REMARKS

Amendment to the Drawings

FIG. 3

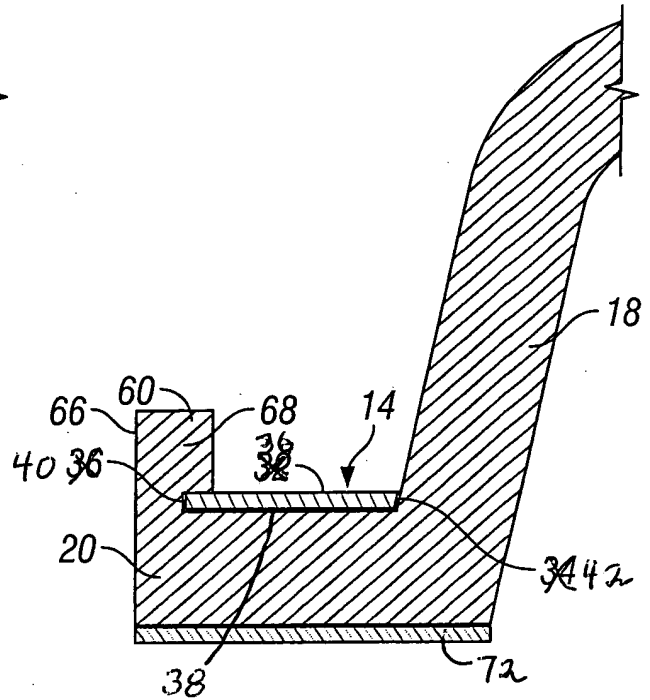
The Applicant has noted the objections to the drawings and has supplied numbers to make it clear that the shank 52 of the fastener 46 extends into the tapped opening 76, with threads 52 registering with and being gripped in the tapped opening 76. In addition, there have been several other changes in the drawings, to eliminate ambiguities and errors. The fasteners, generally designated 46, each have a head portion 48, a flange or washer portion 50 and a threaded shank portion 52. The hold down ring is generally designated 14, but it includes a body portion 36 as well as radially outer and inner edge portions 40, 42 and upwardly and downwardly directed faces 36, 38. Any minor errors that may have occurred are being corrected to ensure that the numbers are correctly placed in the replacement sheets.

The attached two sheets of drawings includes changes to Fig. 1, 3, 4 and 5. These sheets, which includes Fig. 1 and 6 on 1/3 and Figs. 2-5 on 2/3, replace the original sheets. Annotated sheets showing the changes are also attached.
